R.E. Ginna Nuclear Power Plant

**Subject:** Response to Request for Additional Information  
Regarding R.E. Ginna Nuclear Power Plant  
Relief Requests VR-1, VR-2, and VR-13 for  
The Fourth 10-Year Interval Inspection  
Docket No. 50-244

### Response to NRC Request for Additional Information (RAI) Dated June 15, 2004

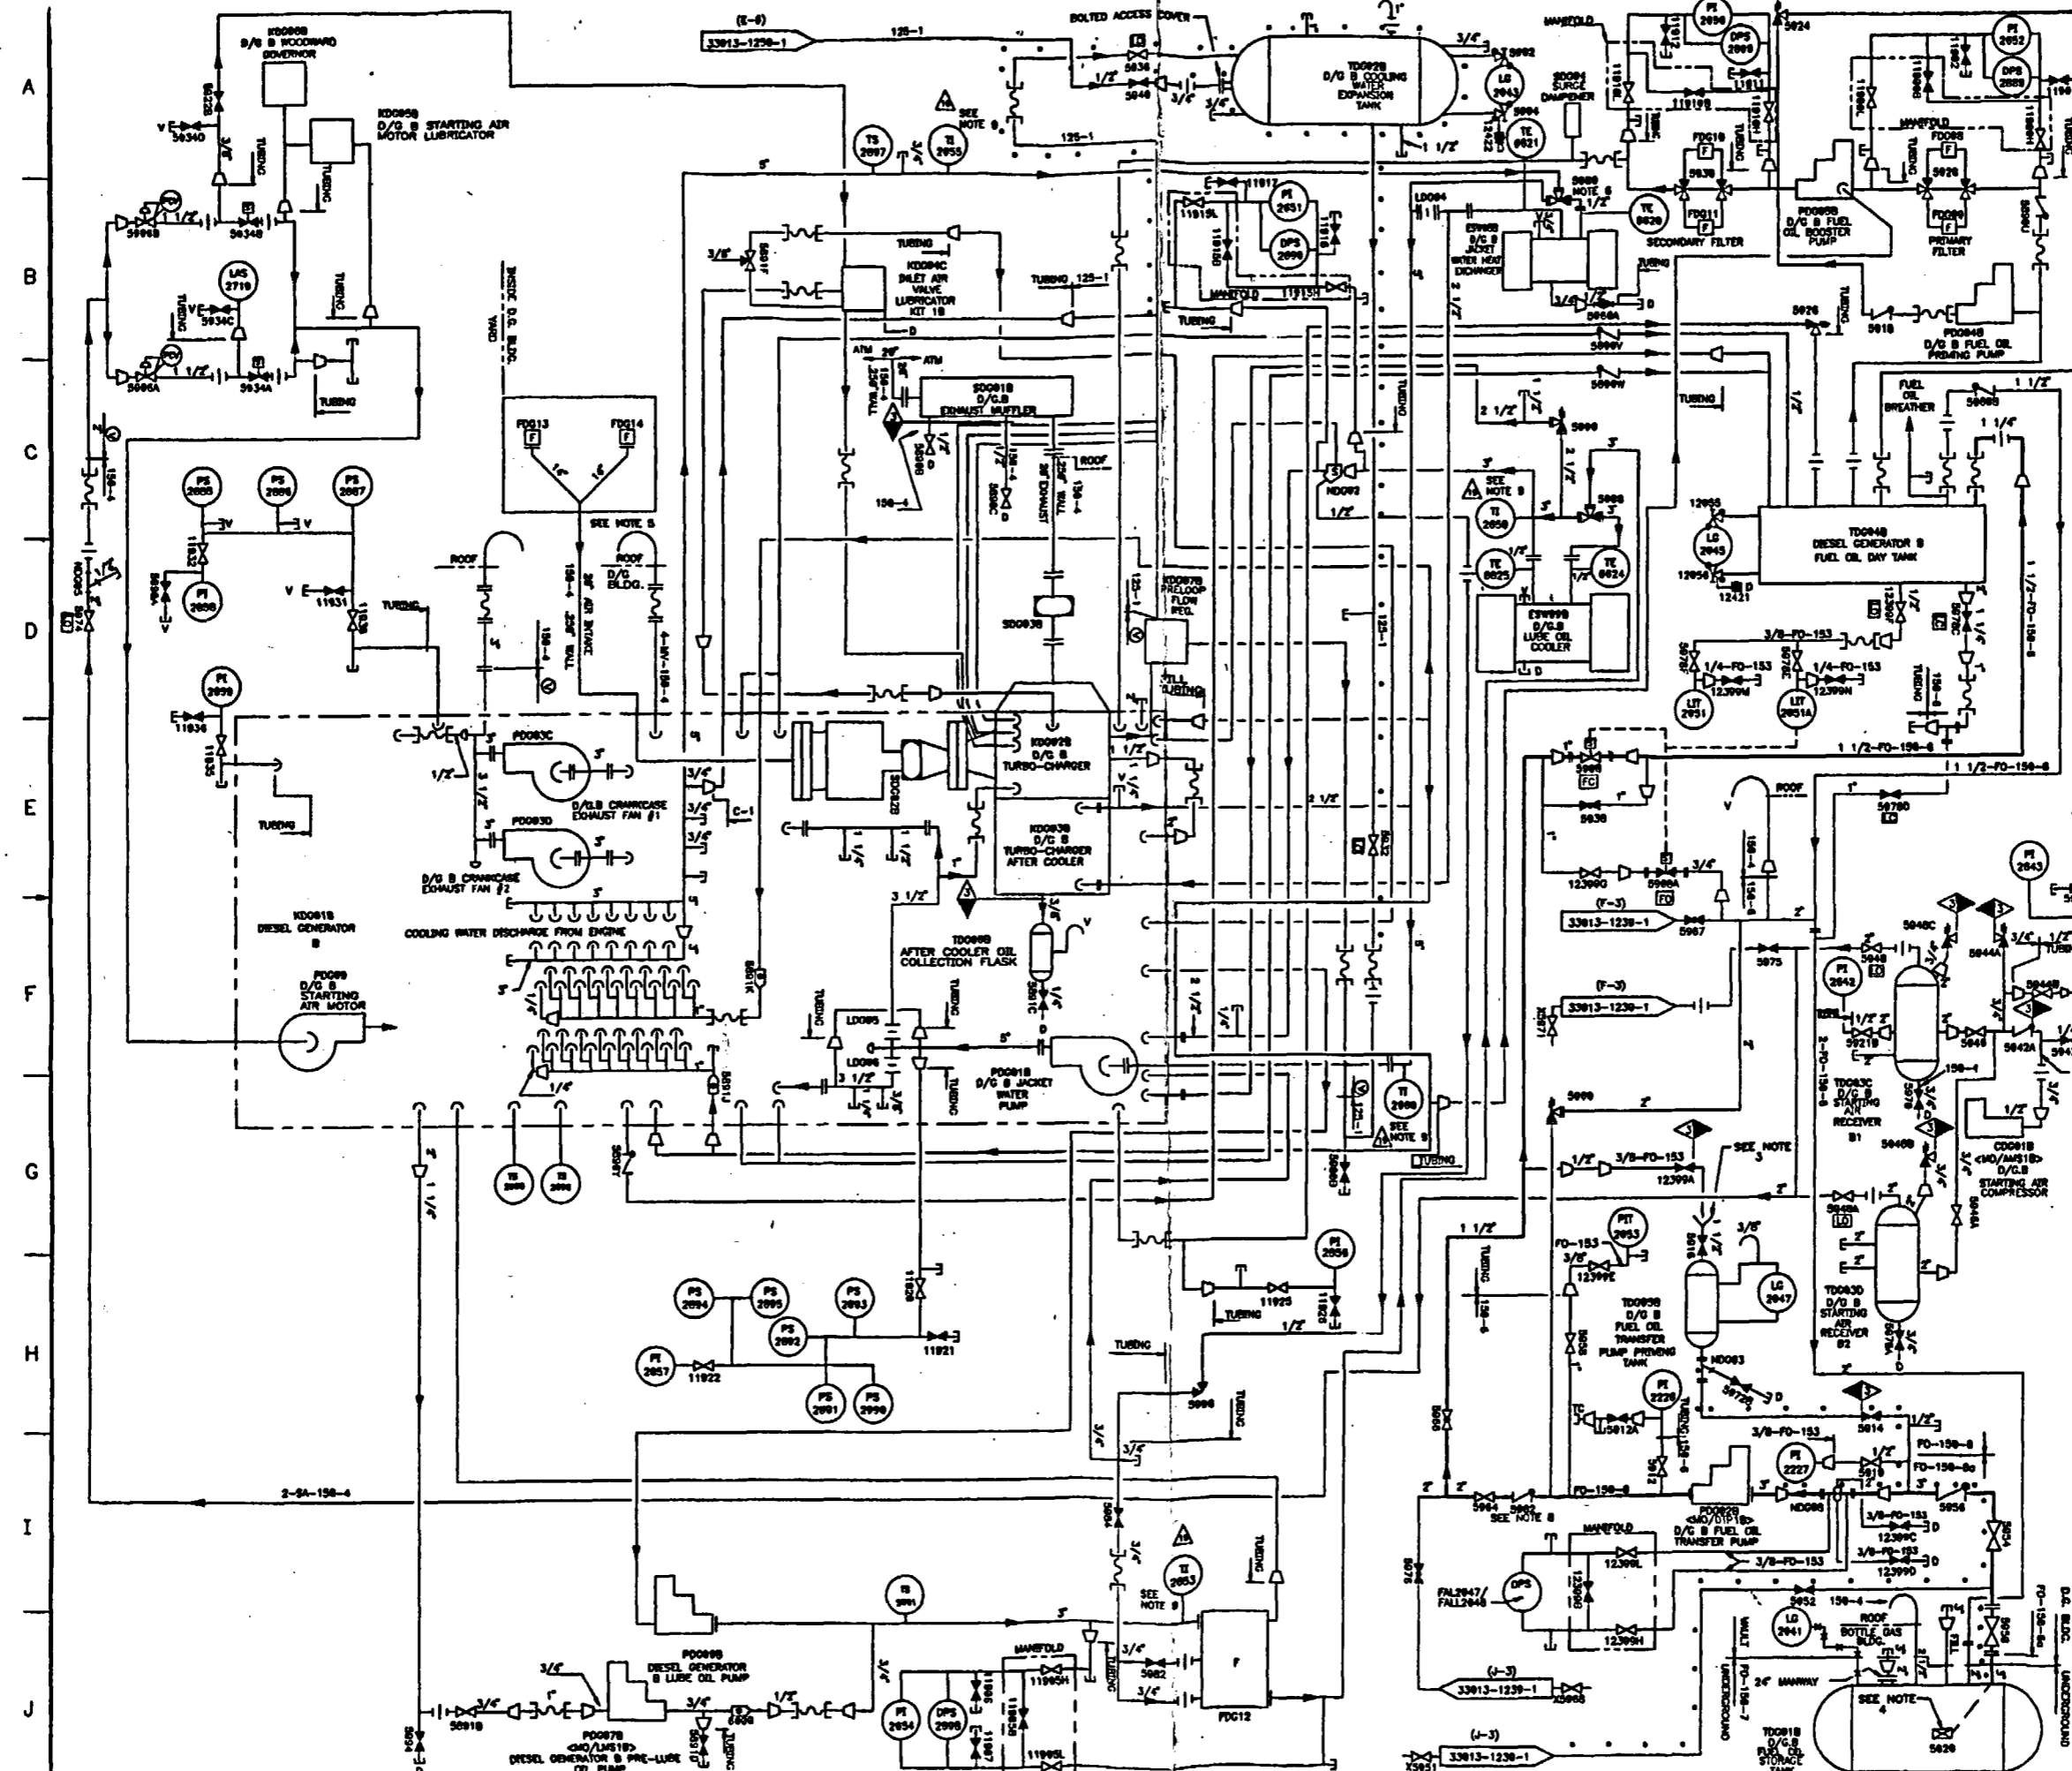
**RAI 6: Provide sufficient information for NRC staff to reach a safety or risk determination with regards to isolation of these check valves when testing on-line. Also provide copies of drawings (P&IDs) showing check valves and isolation valves and provide details how isolation of these check valves will be established.**

**Response:** As noted in response 1 above, these valves will not be flow tested. As shown on the attached drawings (33013-1239 sheet 1 of 2 coordinates C-1 and 33013-1239 sheet 2 of 2 coordinates C-11), there is no difference in isolation of the affected line regardless of the plant status. These valves are in the overflow line from the respective diesel generator fuel oil day tank to the underground main storage tank. There are no isolation valves in the flowpath. Instead, the diesel generator and fuel oil transfer pump will be isolated at the time that the valve inspection and disassembly take place. The line is normally drained.
